TO: Committee of the Whole
FROM: Charity Jones, AICP, Planning & Economic Development Director
SUBJECT: Case 15-05 Seven Oaks Townhomes
DATE: May 12, 2015

Case No. 15-05
Project Name Seven Oaks Townhomes

**RE: *The Townhomes at Seven Oaks
Plan Review #1***

Re: **Seven Oaks Townhouses**
Preliminary Engineering Plan Review

GEOMETRIC PLAN

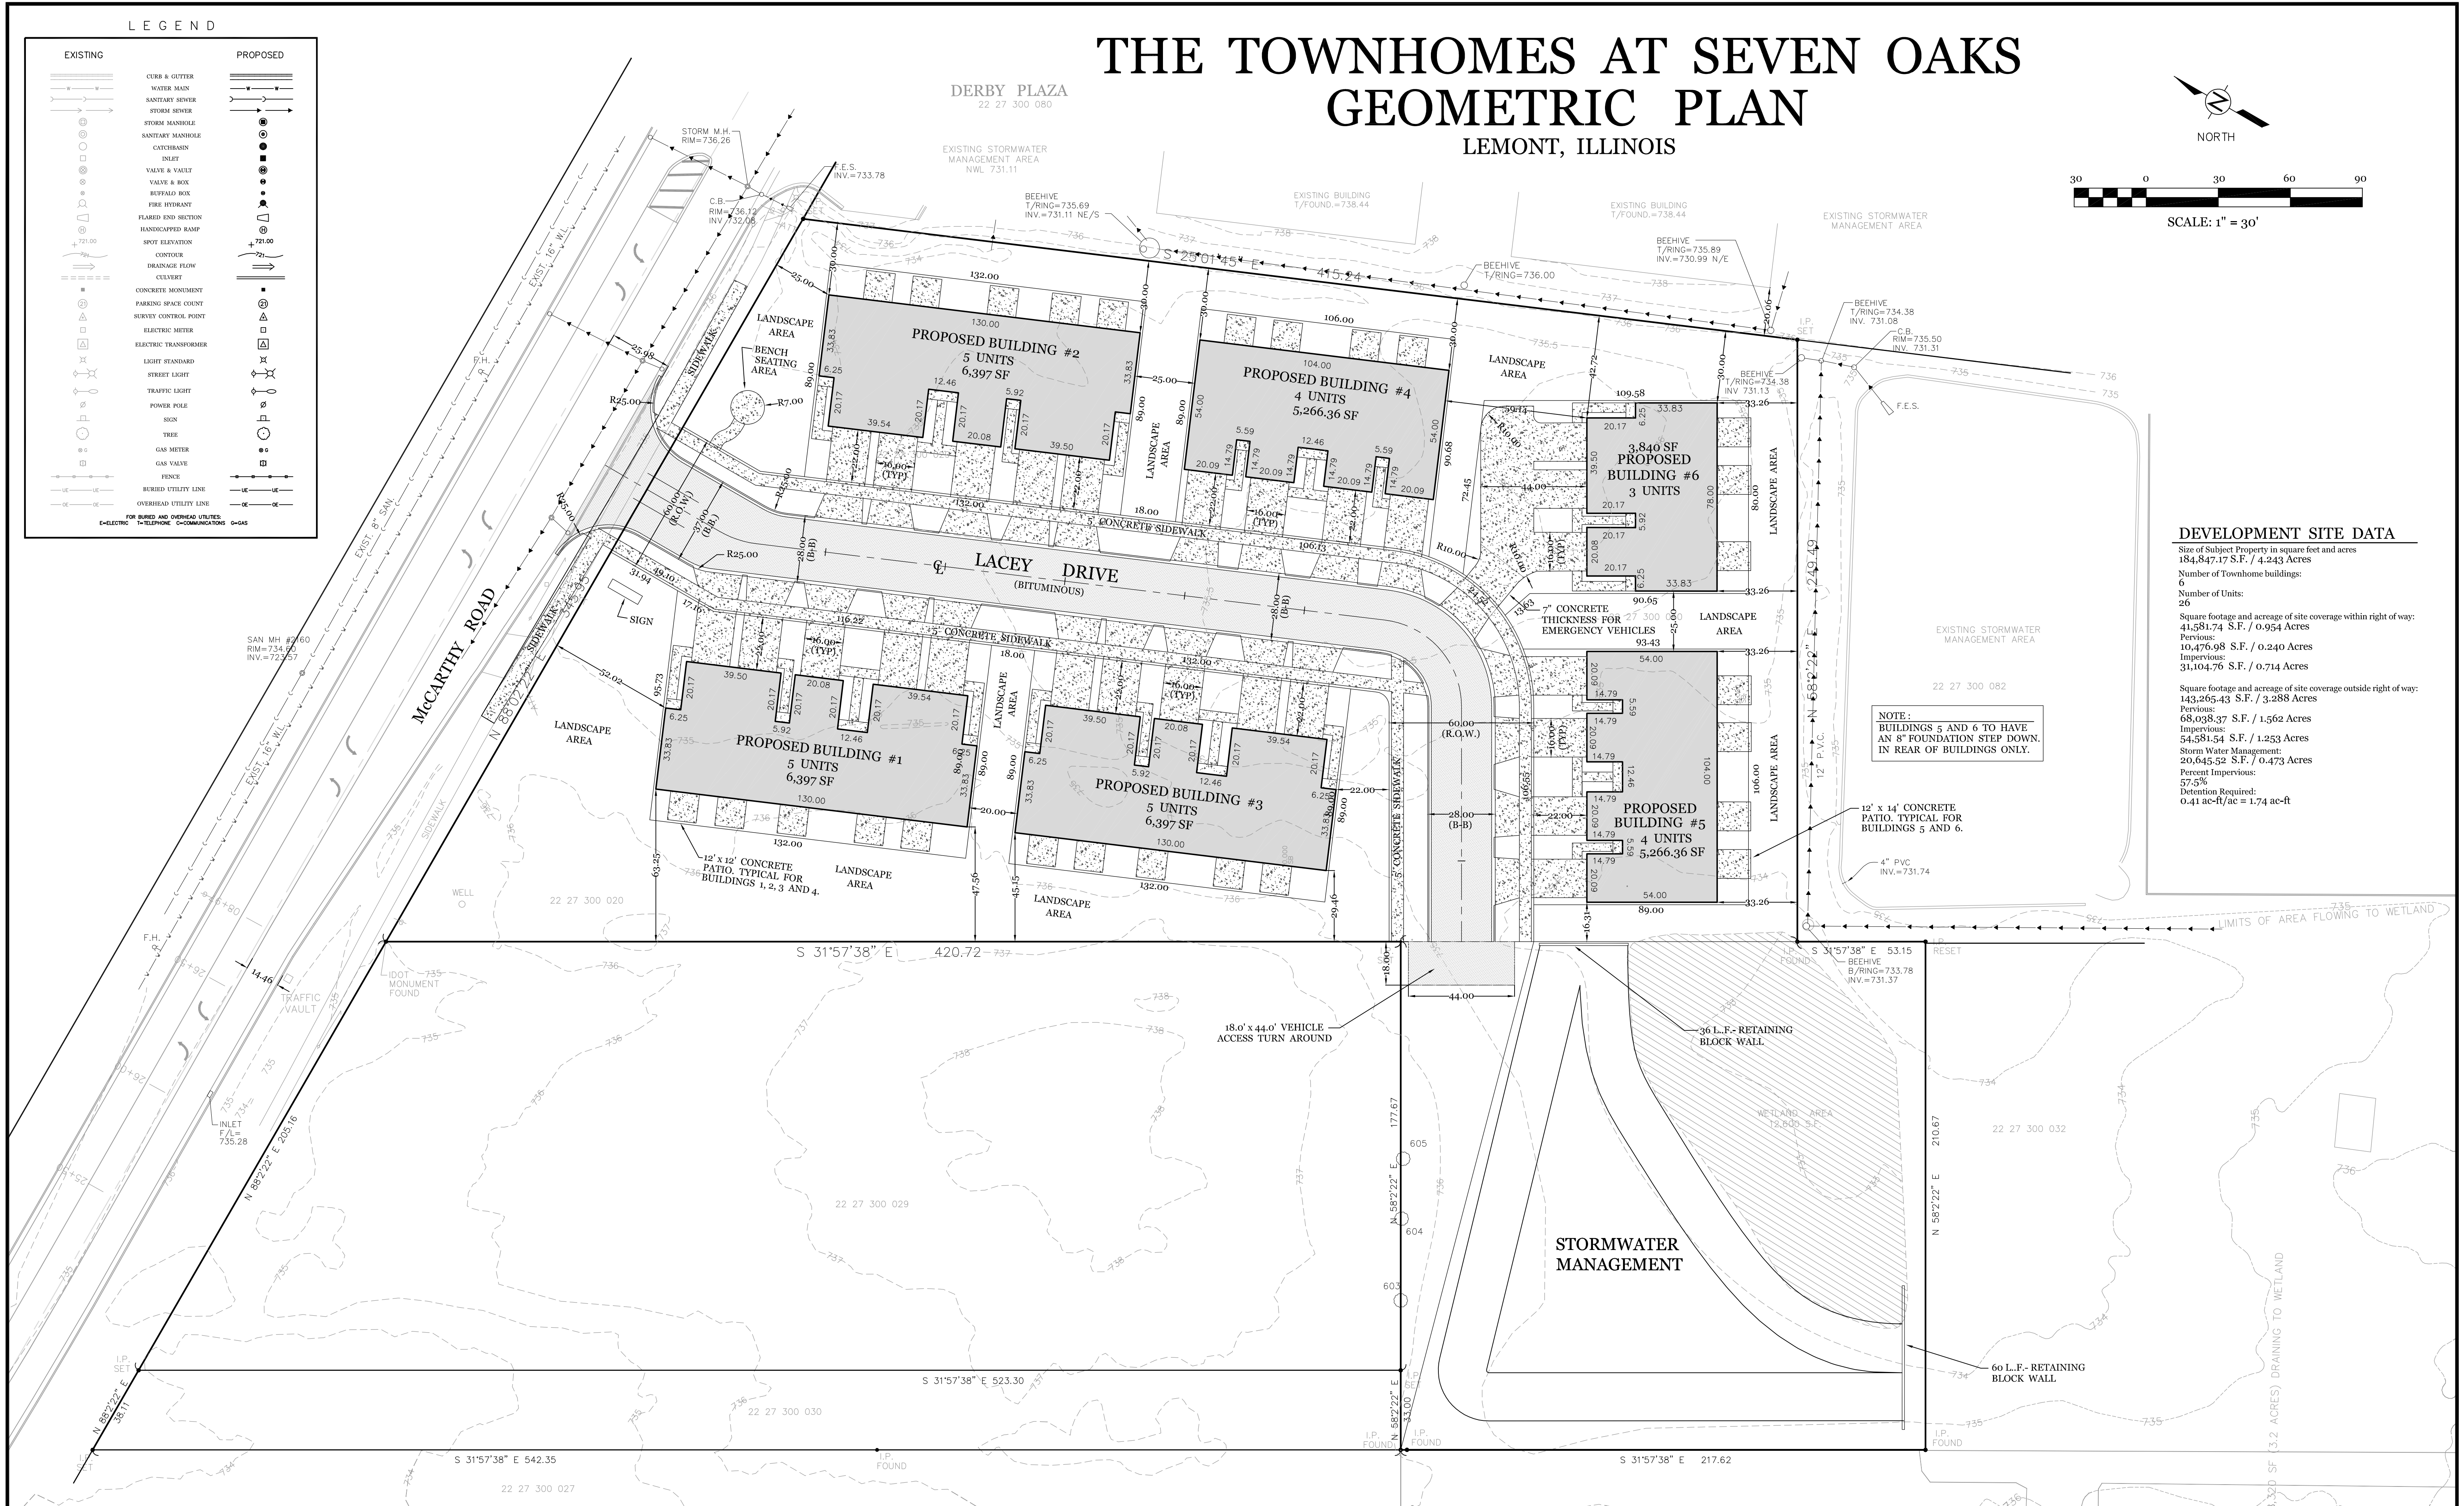
approximately 20 feet from the northern property line. In response to staff concerns, the applicant presented a revised site plan to the PZC that shifted building #1 so the apron is now approximately 33 ft from the property line. This revision reduced the distance between buildings #1 and #3 from 25 ft to 20 ft. The PZC also noted a correction needed on the plat of subdivision.

Traffic & Site Access. The site is proposed to be access from McCarthy Road; the location of the proposed access on McCarthy is generally the same location as the existing curb cut for the property's current access onto McCarthy Road. The applicant has received initial approval for this access location from IDOT. Although Derby Plaza's parking is adjacent to the west property line of the site, there is no cross-access agreement or access easement to allow the subject site to access from Derby Plaza.

Internally, access is provided from the proposed Lacey Drive, which terminates in a hammer head at the southwest portion of the site. The plat of subdivision dedicates the right of way for Lacey Road, as well as the area west of its current terminus, in order to provide access for future development of property immediately to the west of the subject site.

Fire District Comments. The Fire Marshal's comments are attached; he approved the submitted plans as noted. The applicant has revised the site plan to respond to the Fire Marshal's concerns related to the turn-around at the end of Lacey Drive.

2. The site is unusual in that the general flow of stormwater is to the southwest low area, while the only drainage outlet for the site is in the northeast corner of the property. Thus, the site has been built up approximately 3.5 feet in areas to provide positive drainage flow to the southwest detention basin, while at the same time, having the units be 2 feet above the McCarthy Road entrance, and the detention basin high water level.

3. The detention basin 100 year drainage overflow route is located along the south and east portions of the property. The basin and overflow route appear to drain to the Derby Plaza detention basin via an existing connection made during construction of Derby Plaza. The plan is unclear where the actual storm drainage outlet is located. Some detention is also provided in the oversized storm sewer that is to be constructed along the south and east portions of the property. This storm sewer system is hydraulically disconnected from the Lacey Drive storm sewer system and detention basin, so as not to surcharge the rear yard system when the detention basin reaches its high water level.

5. Please verify if the parcel is subject to the Oak Tree Recapture for sanitary sewer.
6. The water main is shown to be "dead end", but needs to be looped back east into Derby Plaza, or north to McCarthy Road.
7. On the Plat of Subdivision, there is a 10-foot wide drainage and utility easement shown at certain locations, yet the Plat also states that "All common areas are hereby dedicated as Public Utility & Drainage Easements". We prefer this blanket easement designation.

EXHIBIT K - SEVEN OAKS BUILDING ELEVATIONS

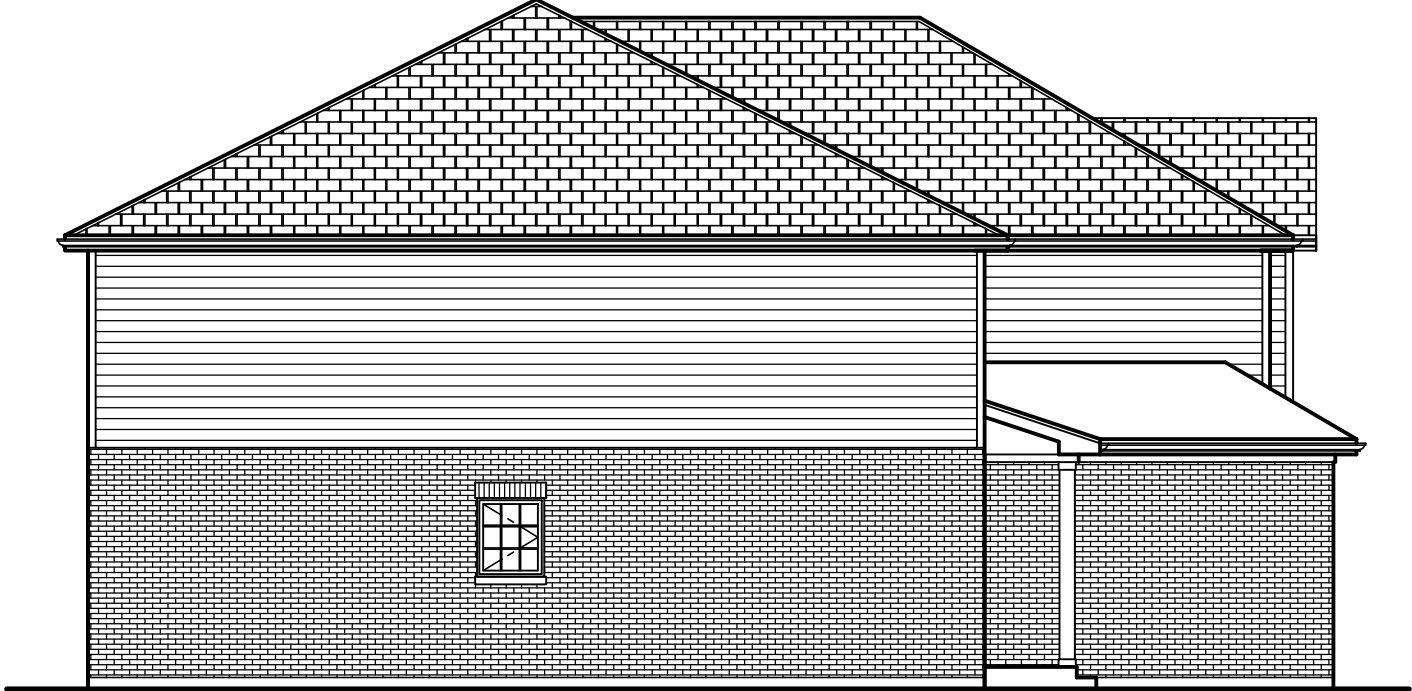
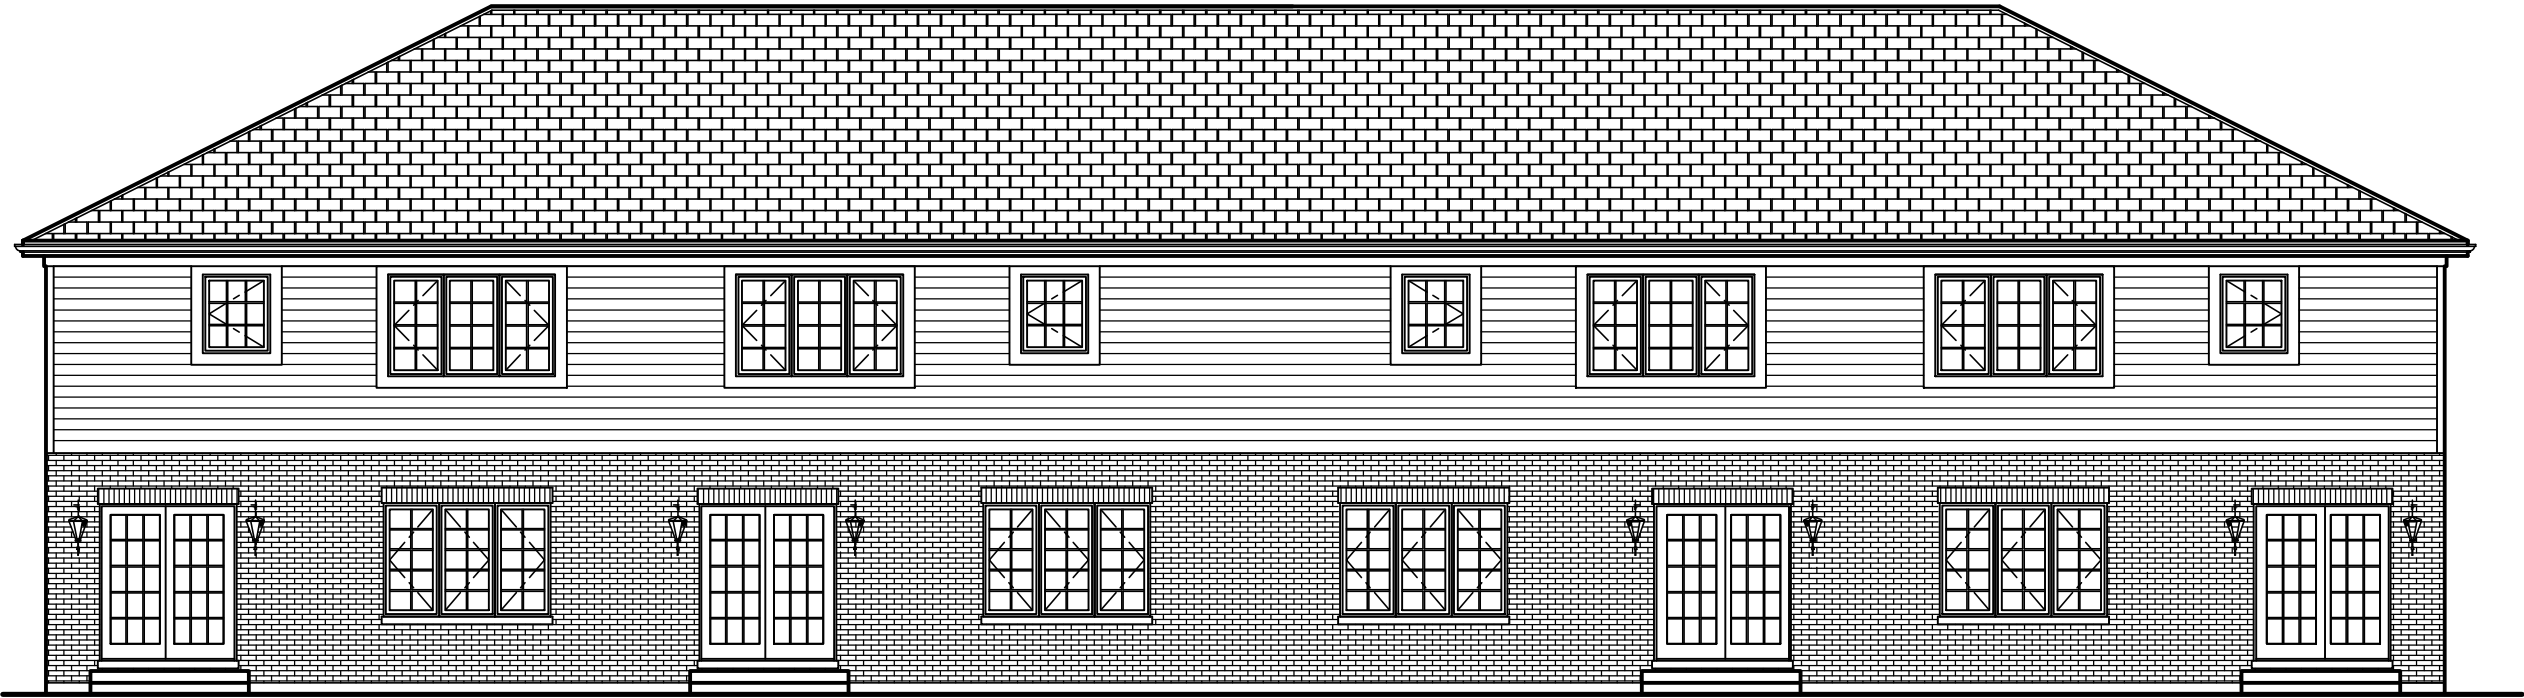
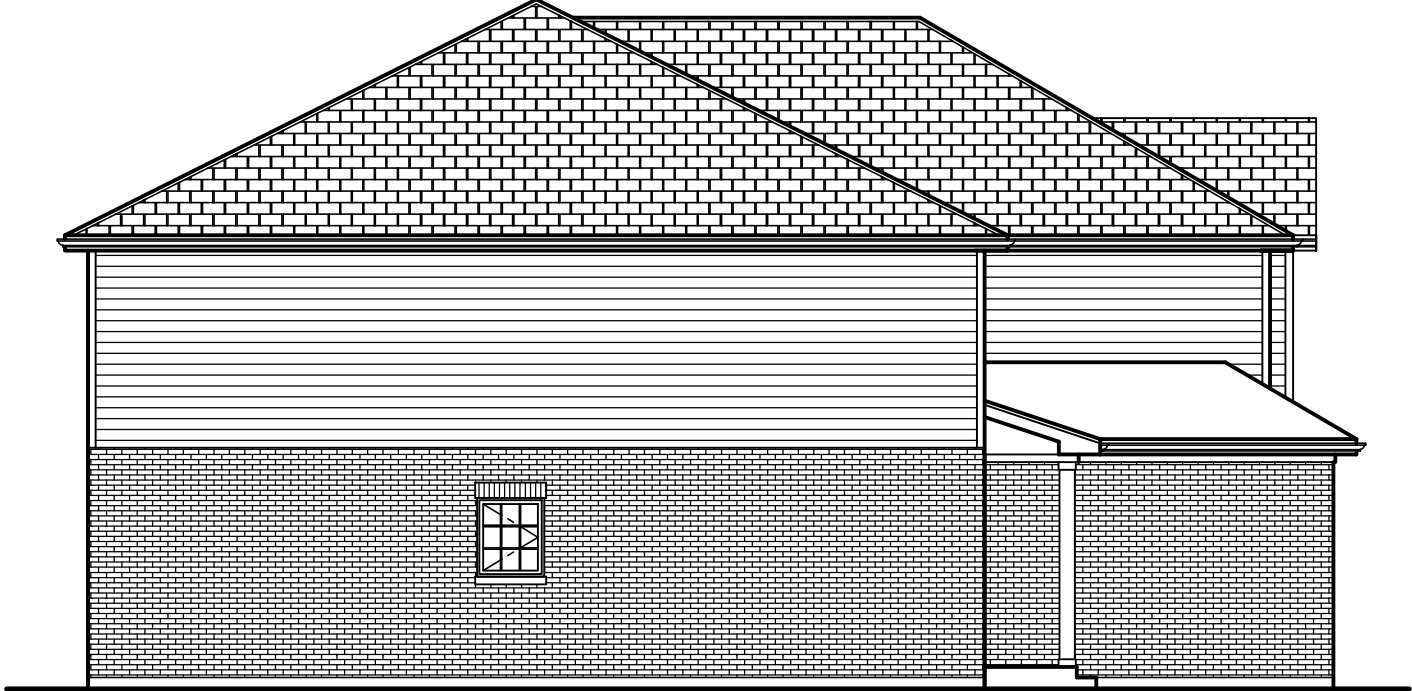
Building & Site Design. Aesthetically, the applicant has provided a logical site design. The proposed buildings are constructed of quality materials and are appropriately designed. The plan proposes three five-unit buildings, two four-unit buildings, and one three-unit building. Five-unit townhome buildings are relatively uncommon within the Village and where they have been constructed in the past they generally feature rear loaded garages, so the building facades facing the public street do not include the garages and driveways. In this development the applicant desires to provide private

outdoor space for the residents of the development; rear loaded garages preclude rear patios or other similar private open space in the rear yard of the townhomes. With rear loaded garages, private open space is generally limited to second story decks and/or front porches. While staff understood the market demand for rear yard open space, staff was concerned with the overall visual dominance of garages and driveways within the development. In response to staff concerns, the applicant has revised his original plans to minimize the dominance of the garages/driveways and improve the appearance of the public realm by:

1. providing windows in garage doors;
2. reducing the driveway width for each unit to 16 ft;
3. rearranging the garages on building #6; and
4. revising the design of the four-unit buildings to separate the driveways from one another.

EXHIBIT I - SEVEN OAKS FINAL LANDSCAPE & TREE PRESERVATION PLAN

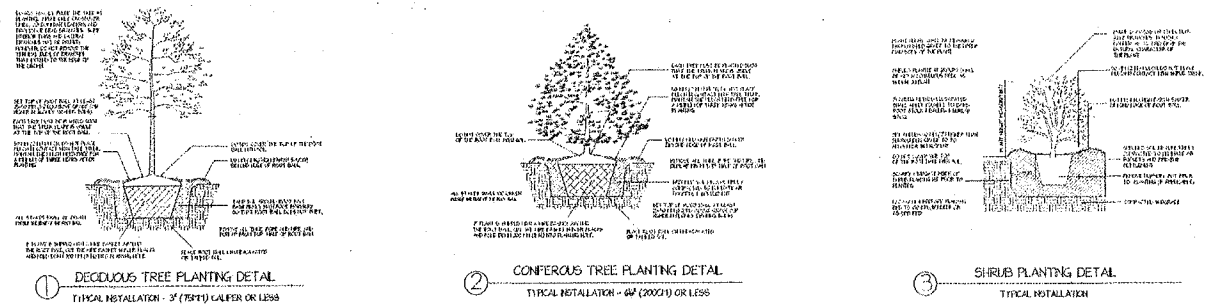
Landscaping. The Village Arborist has reviewed the submitted landscape plan and generally found the proposed landscaping to be acceptable, with some additional clarification needed on the plans. The Arborist noted that the naturalized stormwater detention facility did not include any provisions for the installation and maintenance of the necessary plant material for that area; the applicant has subsequently provided this information and it is currently under review. Additionally, as discussed in the next section, the applicant has agreed to provide additional green space between the side-by-side driveways; the landscape plan should be revised to include ornamental grasses or shrubs within these spaces to reduce the visual impact of the side-by-side driveways.

2. The Final Landscape & Tree Preservation Plan is generally acceptable. It does not, however, show any landscaping in the storm water management area. The Tree Preservation Report indicates that "all of the trees in the naturalized detention basin/wetland area to be removed". The tree survey does not show any trees in the wetland area and the Final Landscape & Tree Preservation Plan does not show the naturalization of the detention basin.

3. If the detention basin is to be naturalized, then the Final Landscape & Tree Preservation Plan should provide for the proper installation, and acceptance procedures for the initial planting and maintenance of these areas.
